**Re: Union Ridge Solar, LLC, Case No. 20-1757-EL-BGN**

## OPSB DATA REQUEST – SECOND SET

### Union Ridge Solar

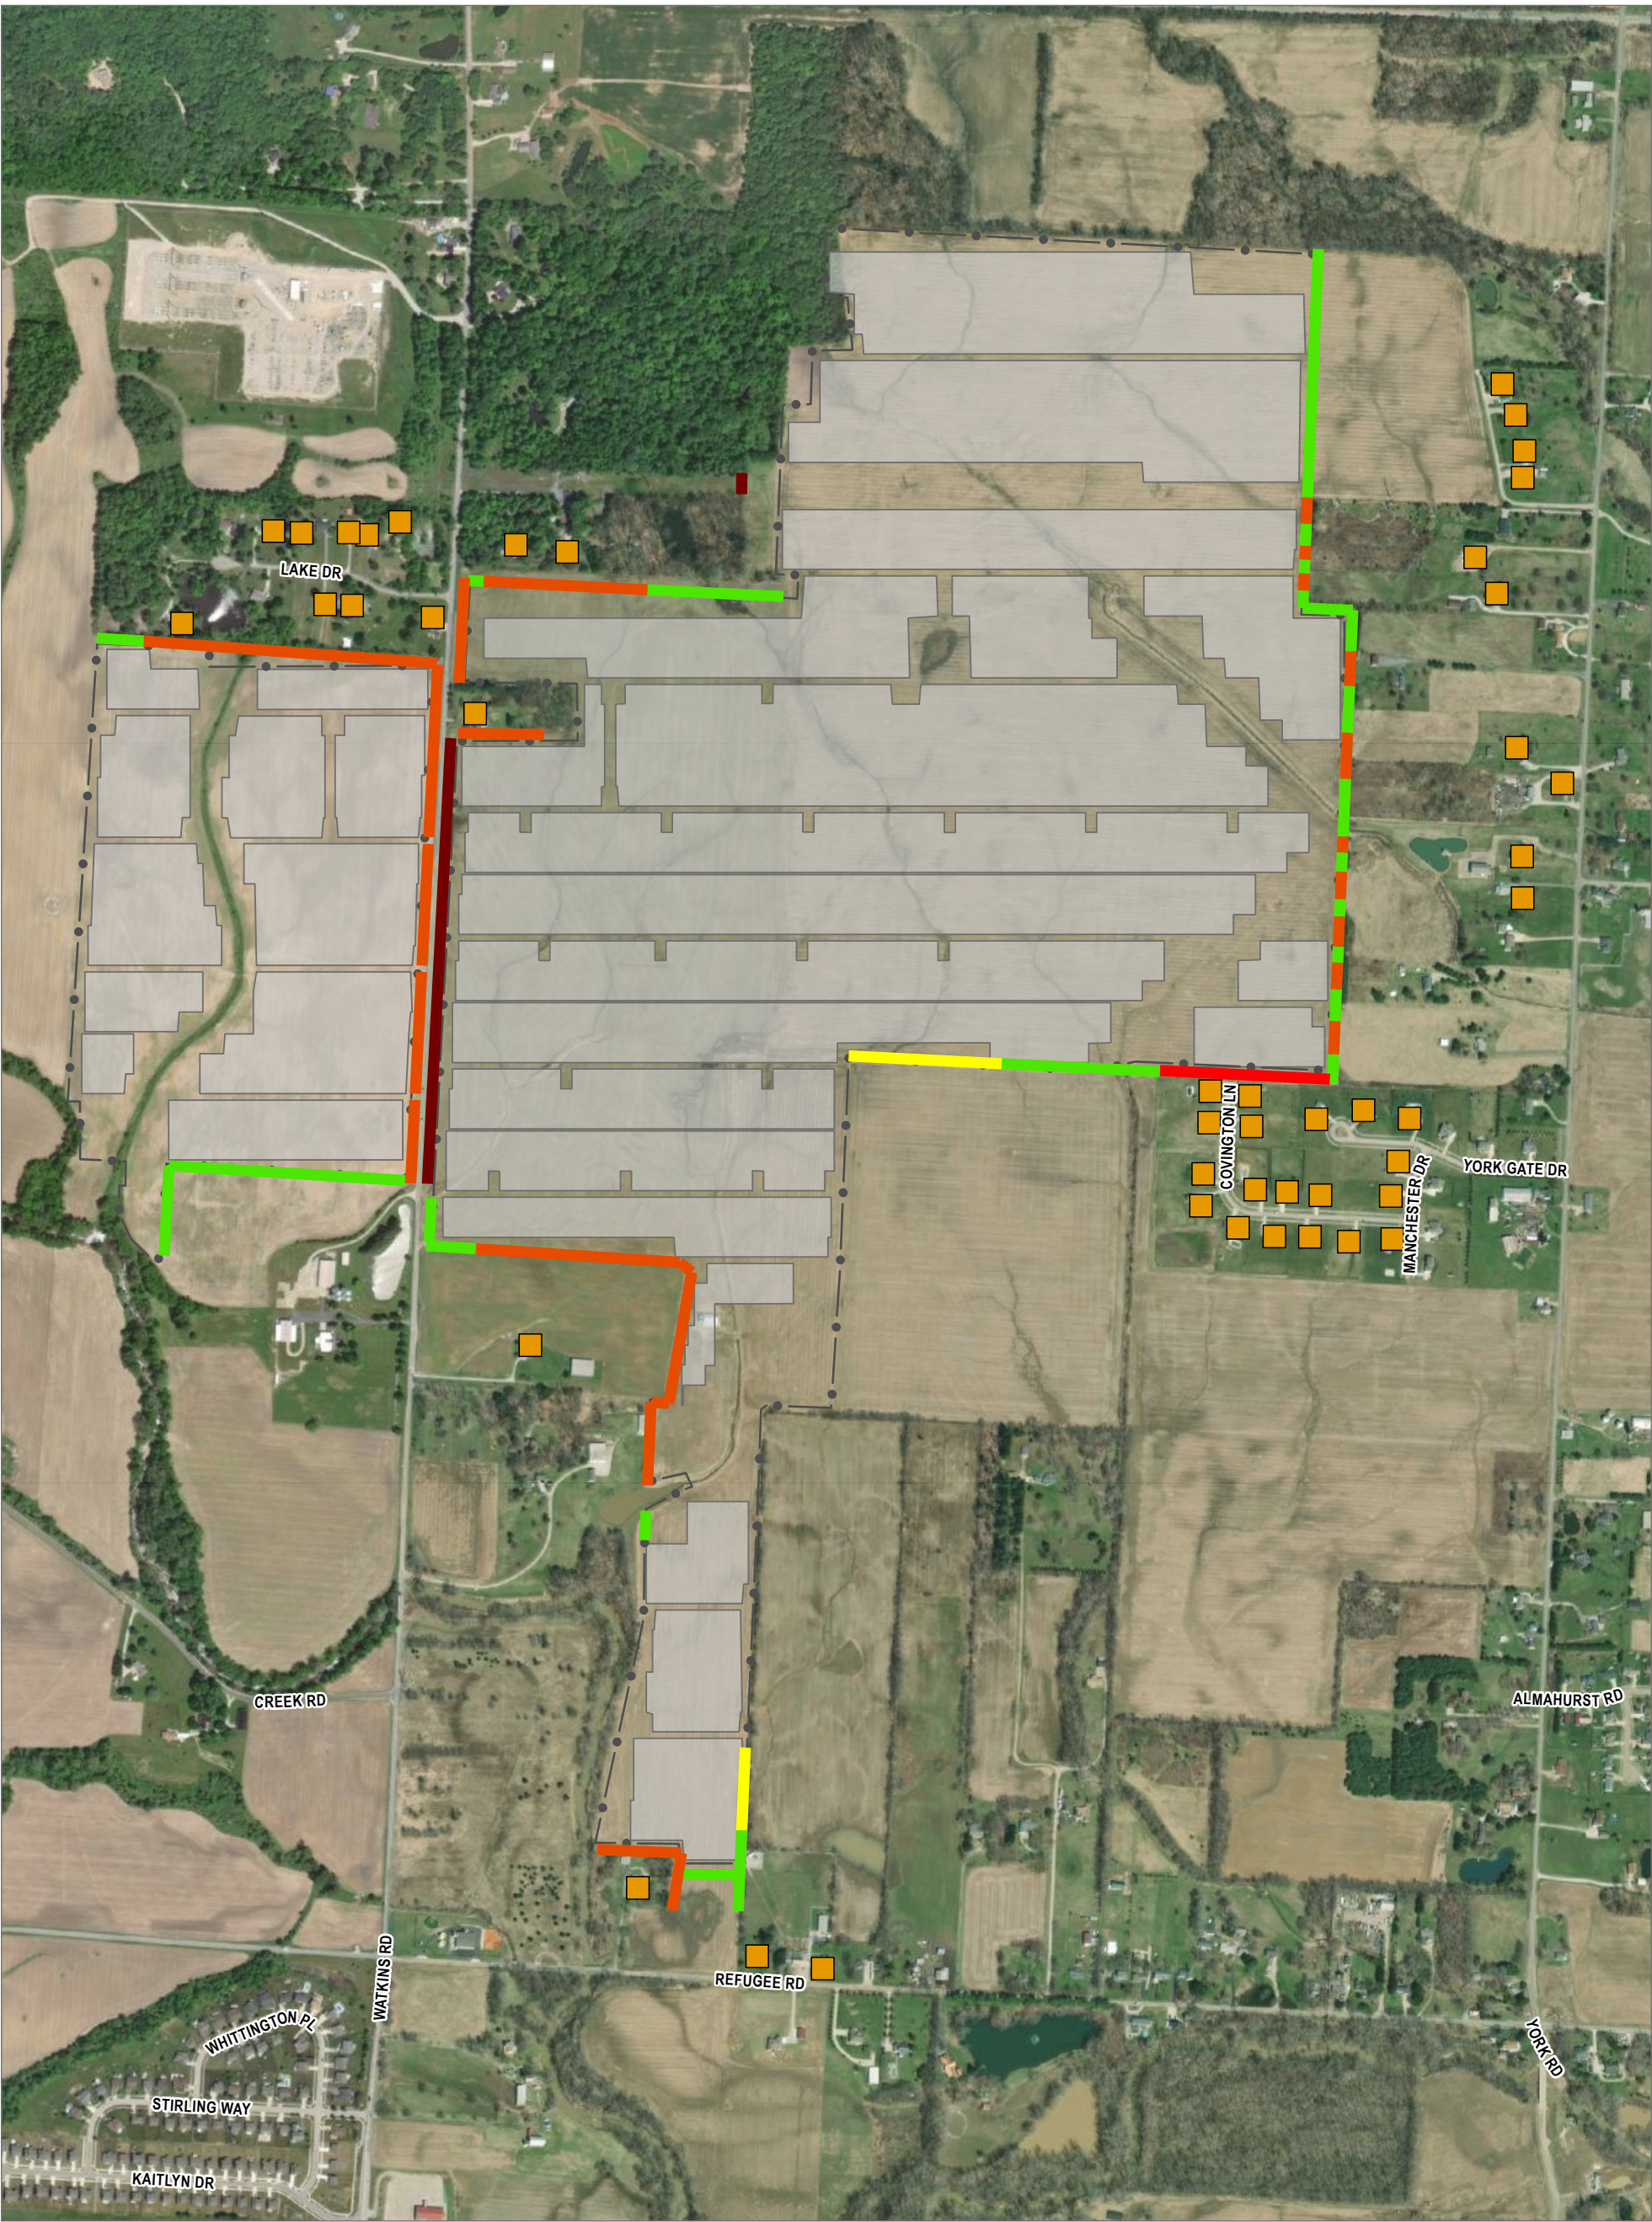
8. ***What is the closest distance from generation equipment to 1) a non-participating property line, 2) a non-participating residence, 3) a public road?***

Response:

Closest distance from a non-participating property line to a PV panel: 25 ft.

Closest distance from a non-participating residence to a PV panel: 133 ft.

Closest distance from a public road to a PV panel: 80 ft.

A change in the layout occurred prior to Application submittal to ensure that the setbacks above were met. This change was not reflected in Table 08-2 in the application, where parcels are listed as closer than 25 ft. to a PV Panel. However, the change is reflected in the layout in the Application and in the measurements above. Therefore no panel is closer than 25 feet from a non-participating property line, consistent with the setback standards provided in section 4906-4-04(B) of the Application. Furthermore, as discussed in Appendix B of Exhibit S of the Application, Union Ridge Solar incorporated feedback from local officials and residents in the vicinity of the Project Area to develop a screening plan that is consistent with the needs of the community.
